Technical Service Bulletin: TSB200054

**New Exhaust Gas Recirculation (EGR) Temperature Sensor Connector Back Shell:
Fault Codes 2375, 2376, and 1867**

Figure 1, EGR Temperature Sensor Boot Location.

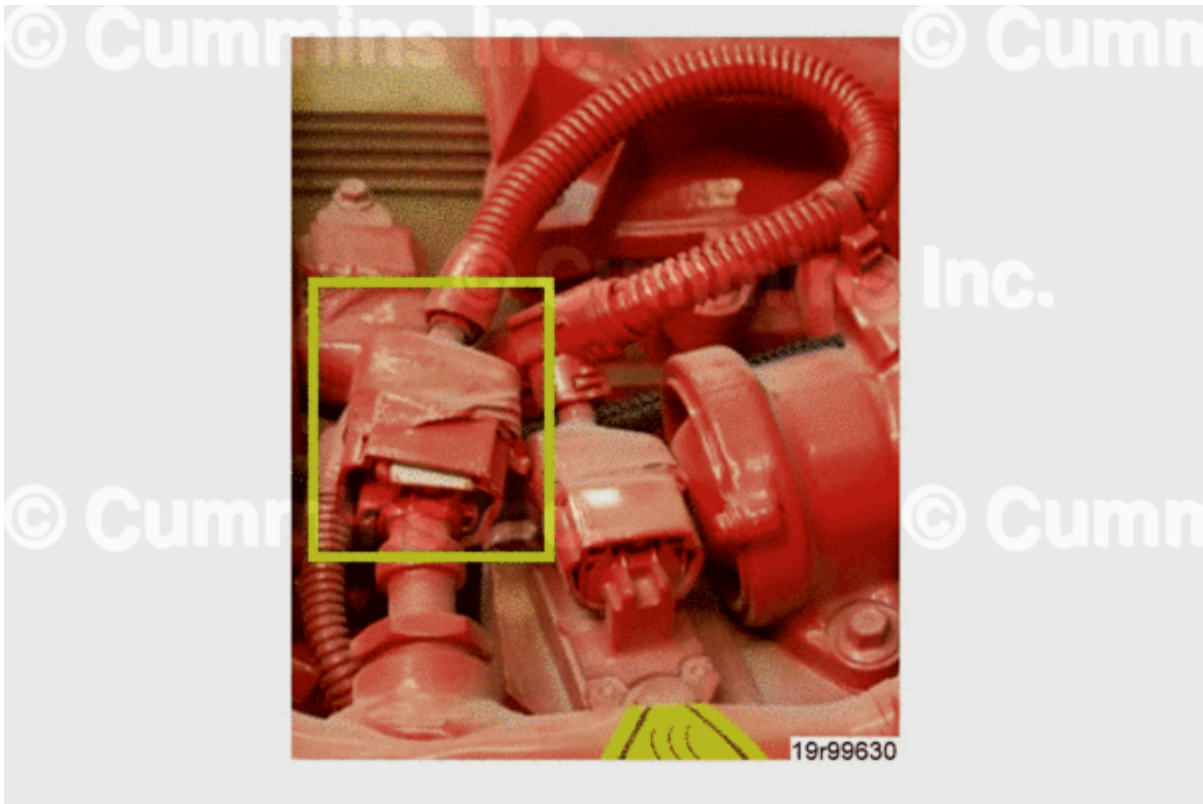
Verify non-transit bus engine which has a rubber boot over the EGR temperature sensor. See Figure 1 below.

Figure 2, EGR Temperature Sensor Tape and Boot Removal.

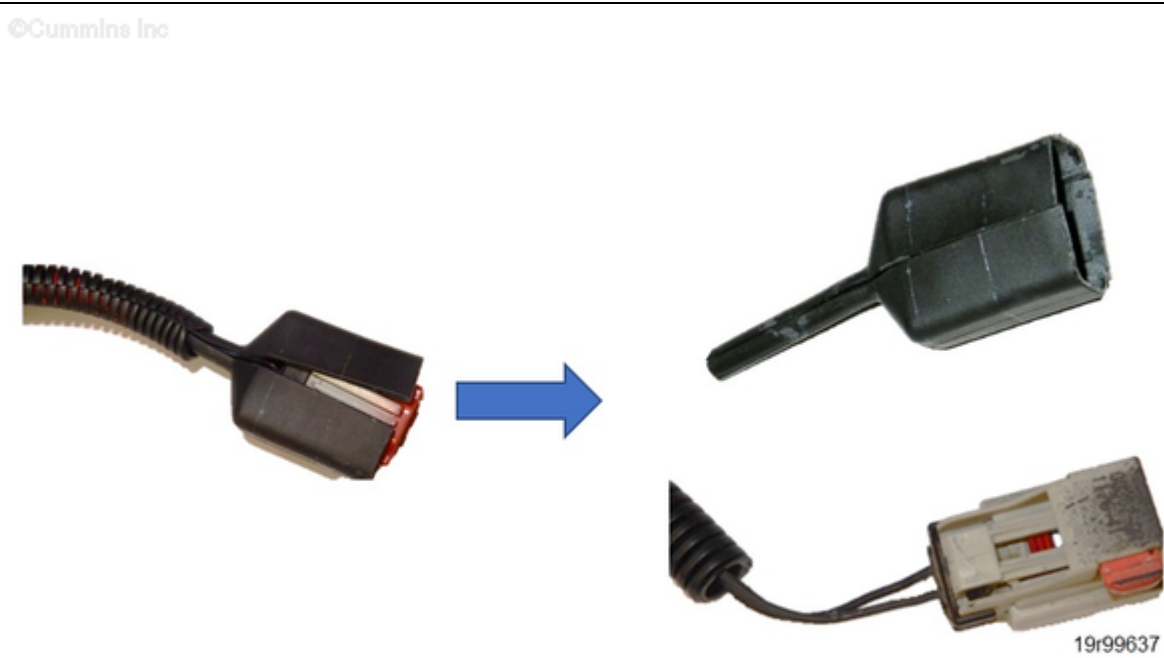
1. Remove the EGR temperature sensor tape and rubber boot. See Figure 2 below.

Figure 5, New EGR Temperature Sensor Back Shell Connector Installed Showing Incorrect Conduit Depth (Too High).

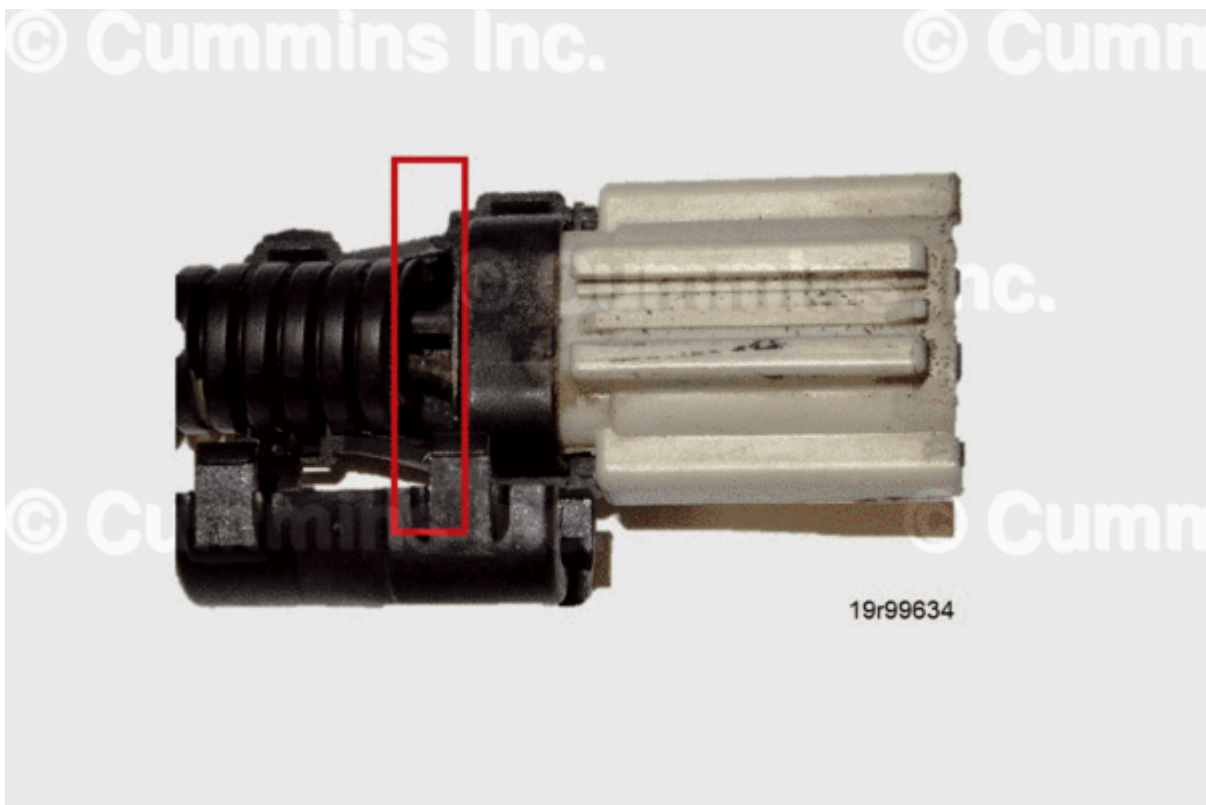
2. Replace the EGR temperature sensor connector using service kit, Part Number 5394319, if the wires are found to be damaged, or if connection appears to be intermittent.
3. Wrap the wires at the EGR Temperature Sensor Connector with electrical tape starting 13 mm [½ in]. behind the connector and extending for 75 mm [3 in] down the length of the wires (to protect the wires)
4. Reference the Figures below and snap the EGR temperature sensor connector back shell, Part Number 4402567, onto the EGR temperature sensor connector and over the conduit. Verify wires are **not** pinched and conduit is fully inserted into the EGR temperature sensor connector back shell. See Figures below for more examples.
